ADDENDUM NO. 1

November 12, 2018

RE: **VILLAGE DISTRICT OF EIDELWEISS, MADISON, NH
WATER SYSTEM IMPROVEMENTS REINACH CAST-IN-PLACE
STORAGE TANK**

FROM: DuBOIS & KING, INC.
831 Union Ave., Suite 2
Laconia, NH 03246
(603) 524-1166

SHEET NUMBER
C-3
SHEET 14 OF 13

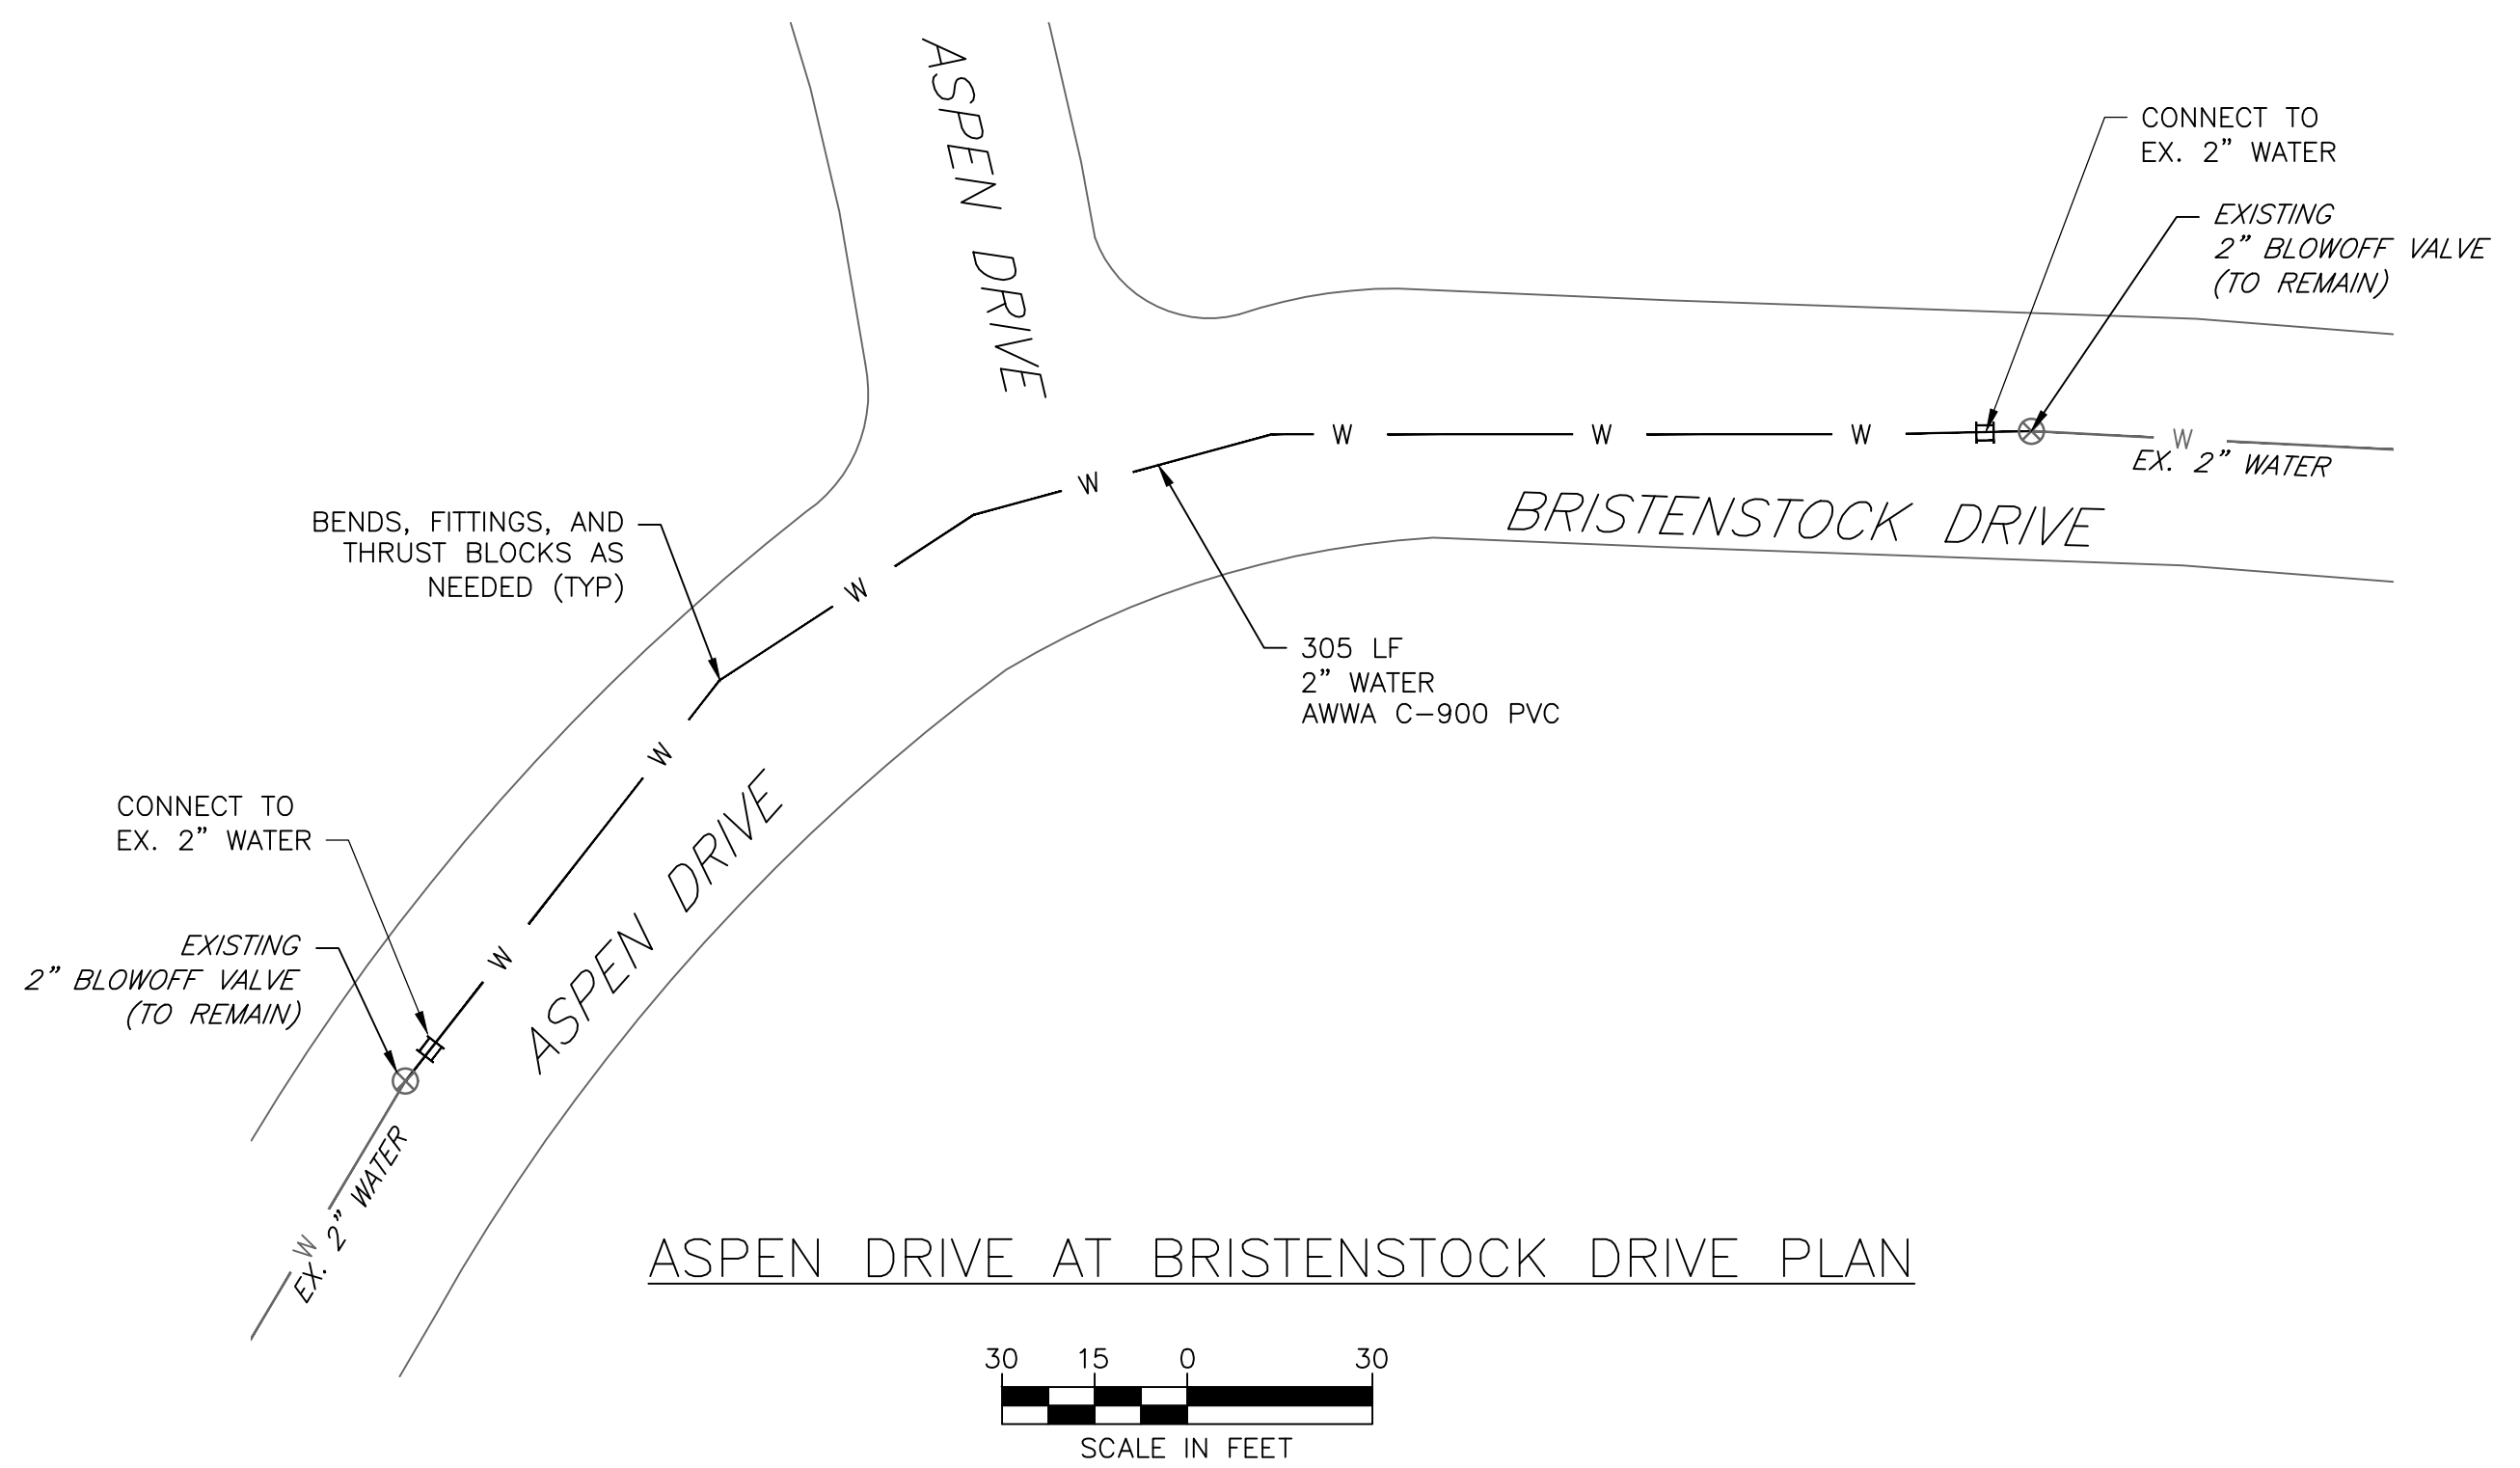
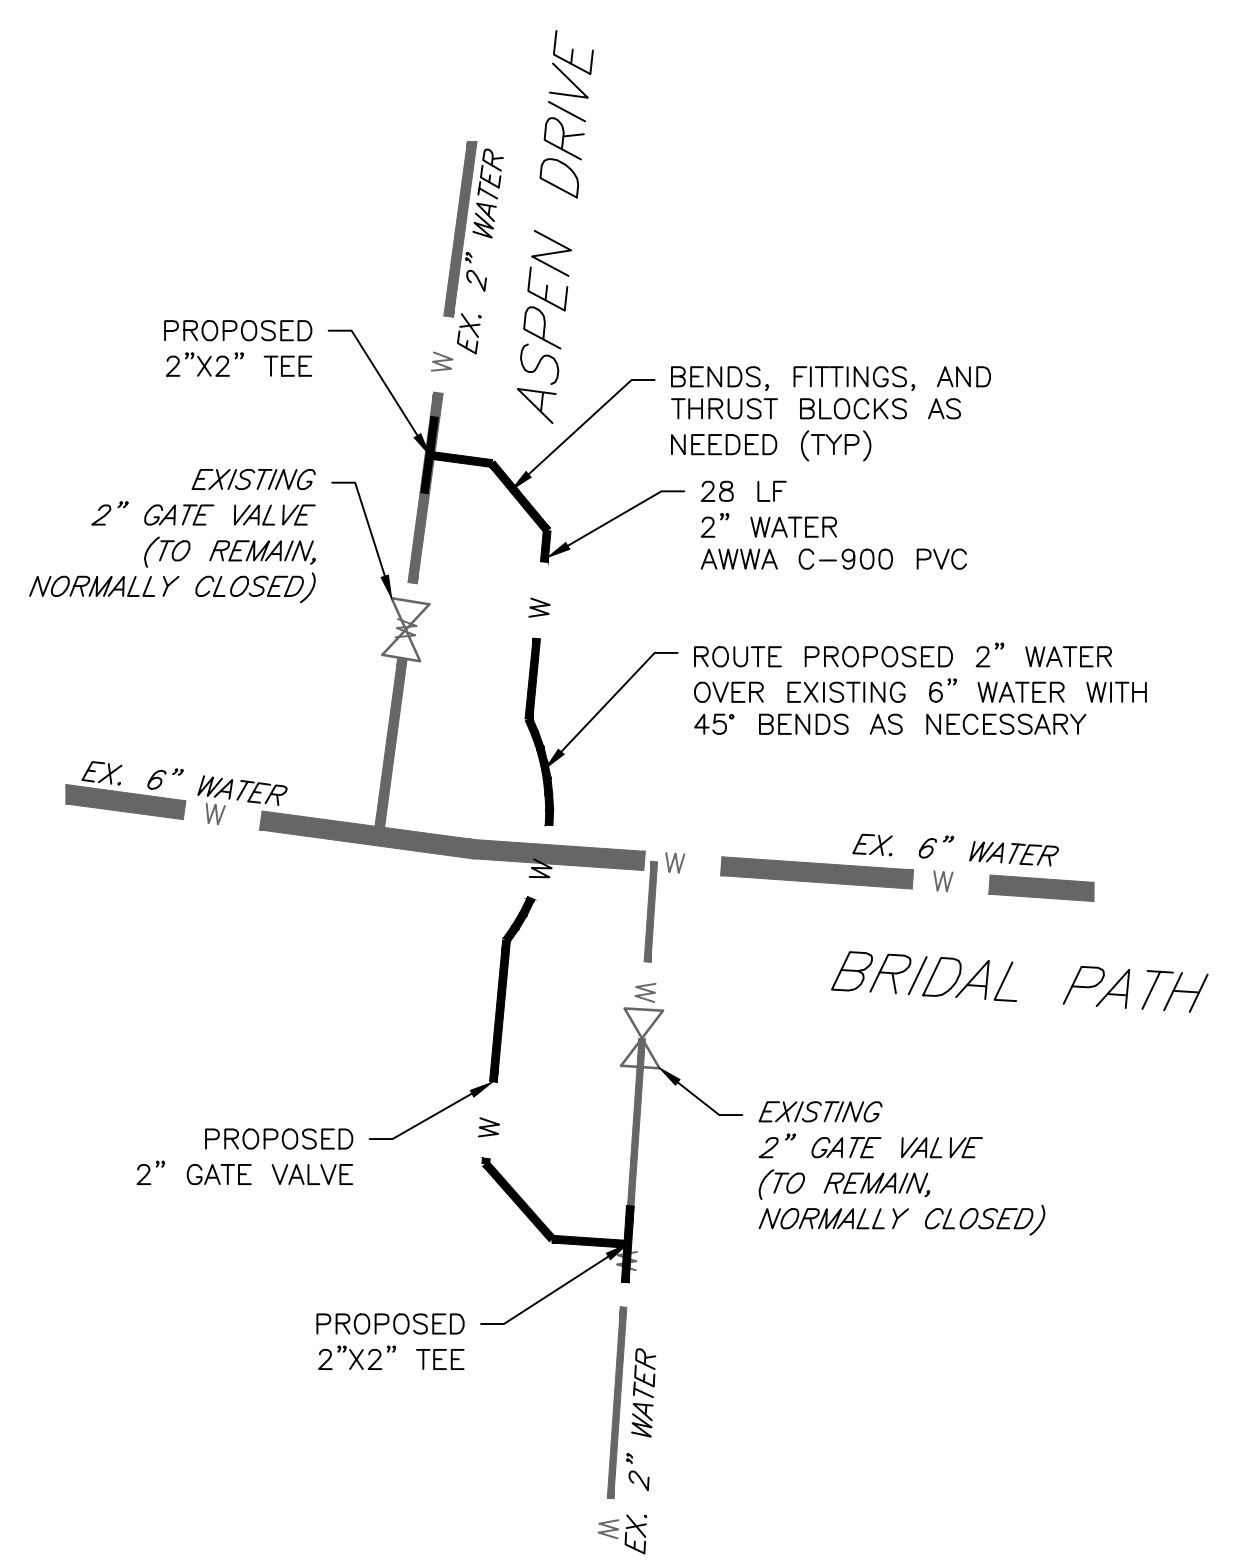
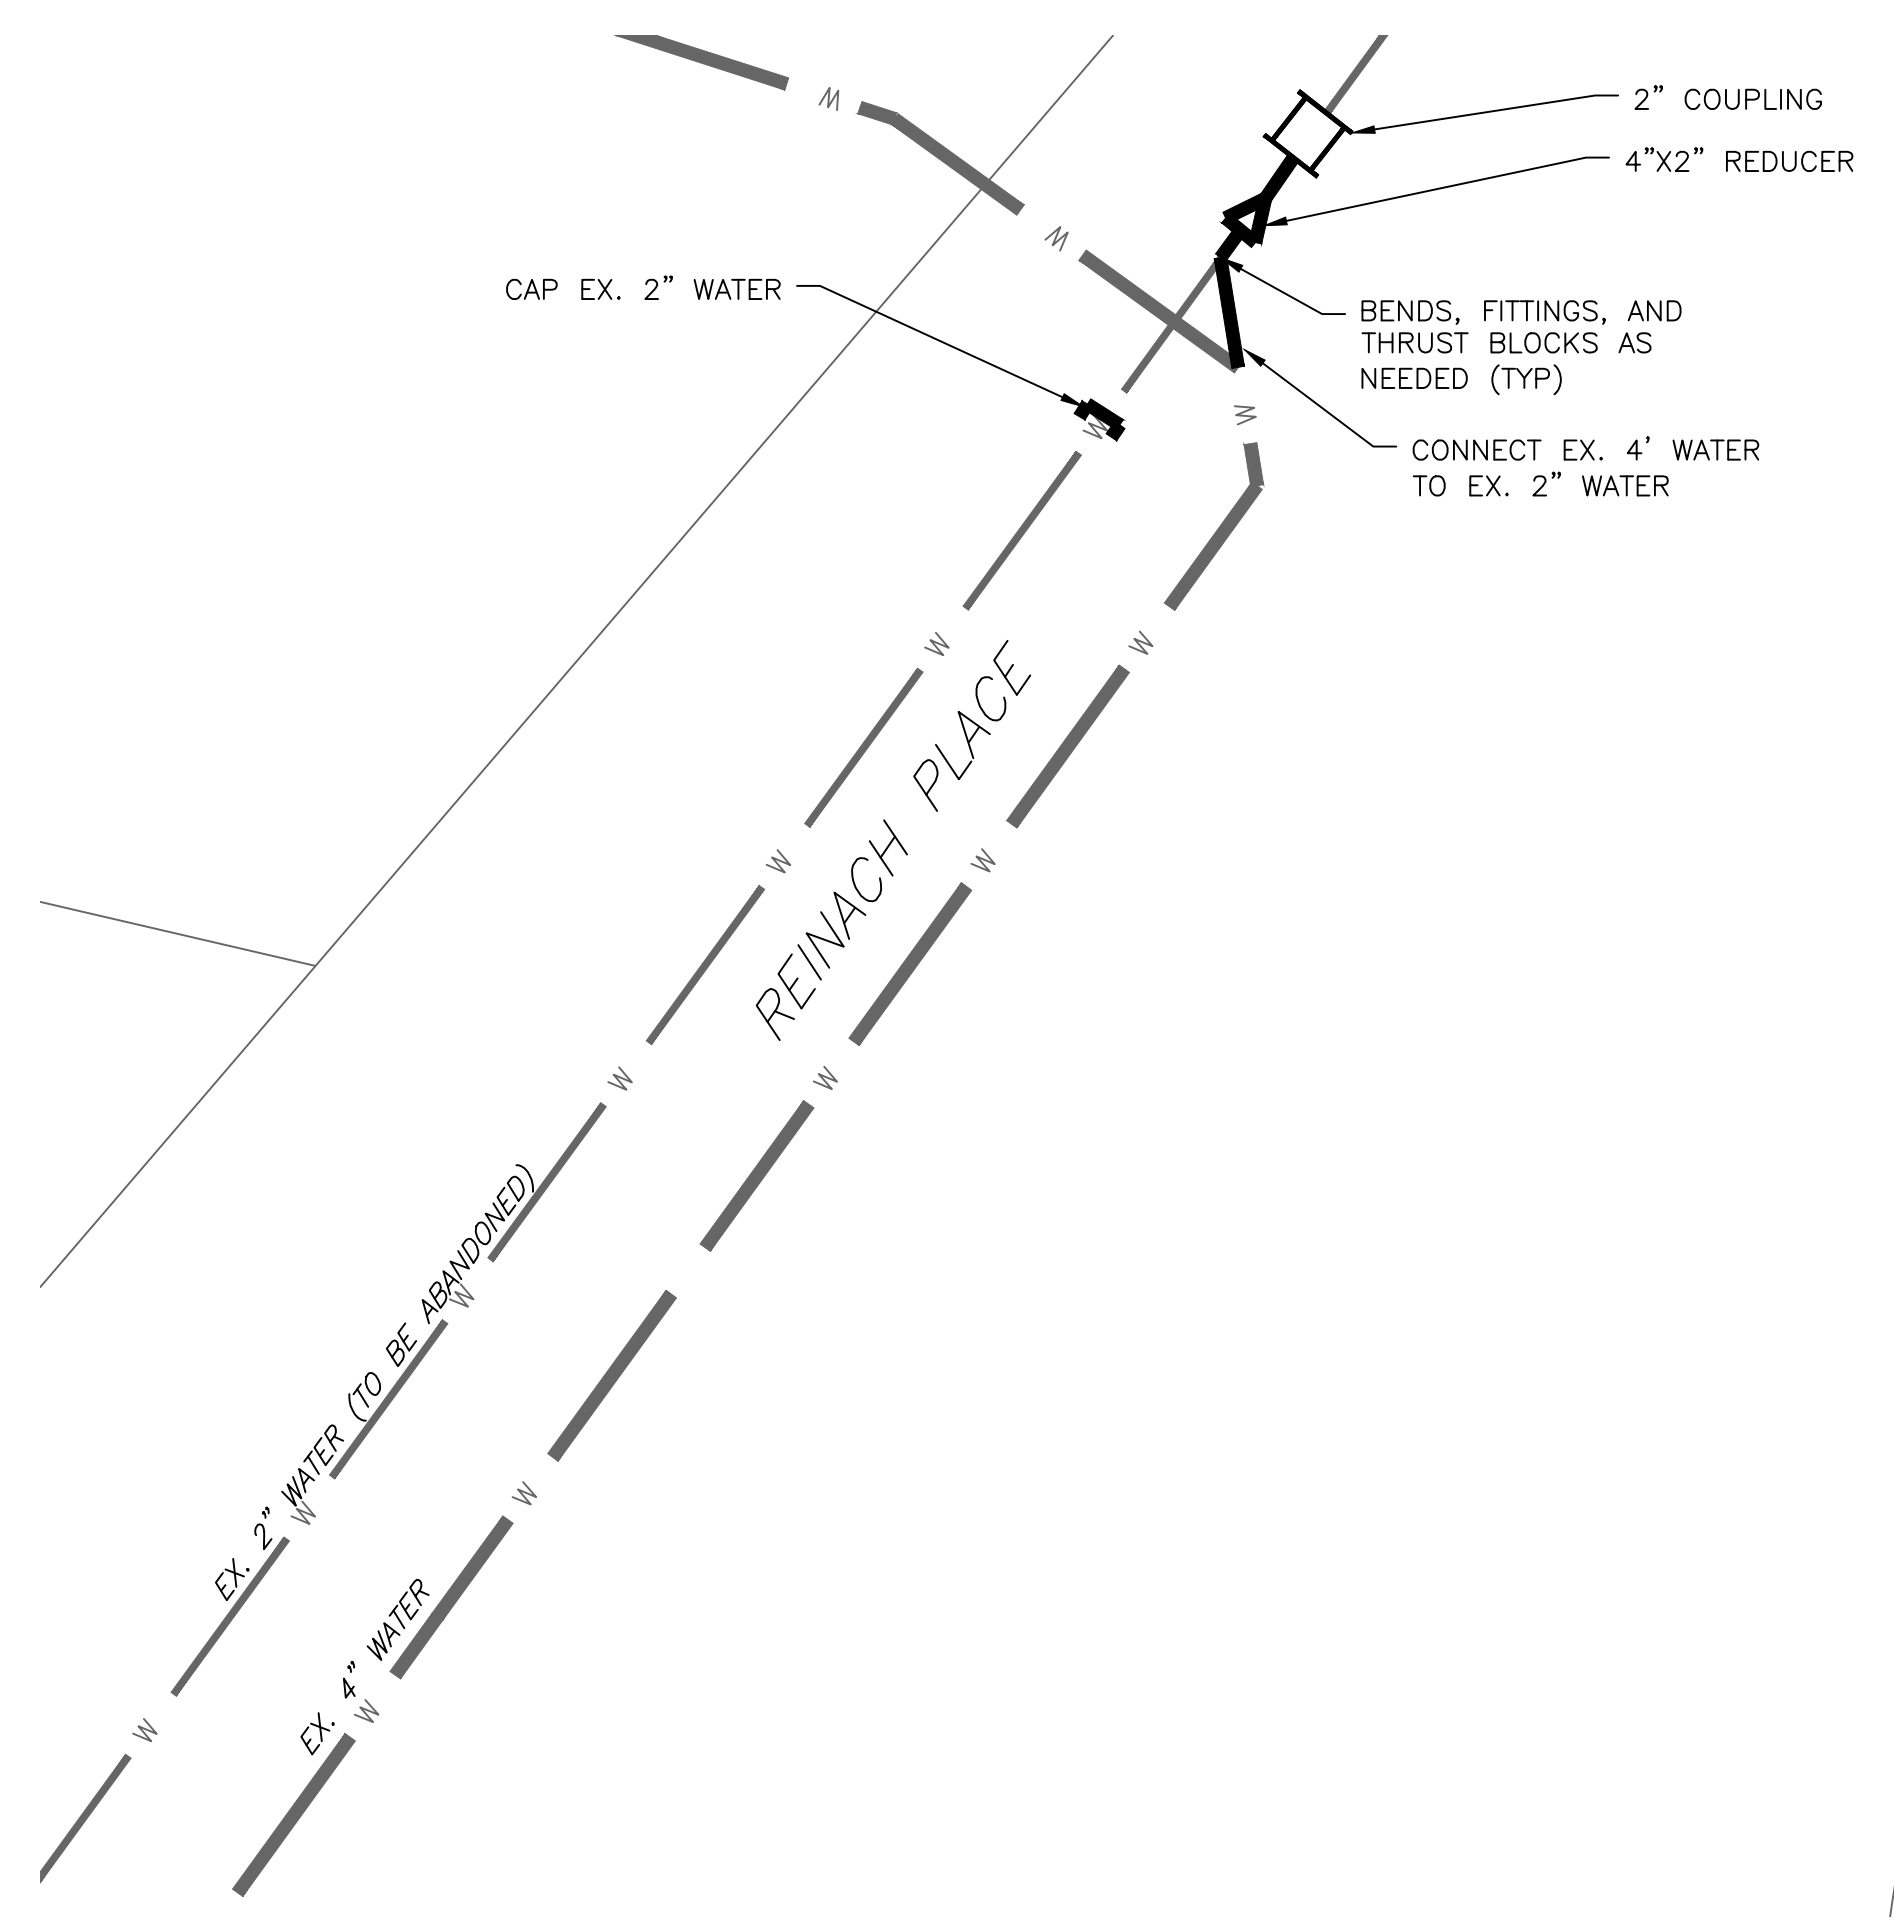
Payment shall be lump sum for distribution system improvements identified on Supplemental Drawing C-3, including cost for all pipes, valves, valve boxes and covers, fittings, adapters, excavation, bedding, installation, connections to existing piping, backfilling, compaction, unpaved surface restoration, disinfection, and testing. Rock excavation and disposal shall be paid for under pay item 9a – Trench Rock. Trench paving shall be paid for under pay item 13 – Road Repairs.

1. Add Sheet C-3 – Distribution Improvements
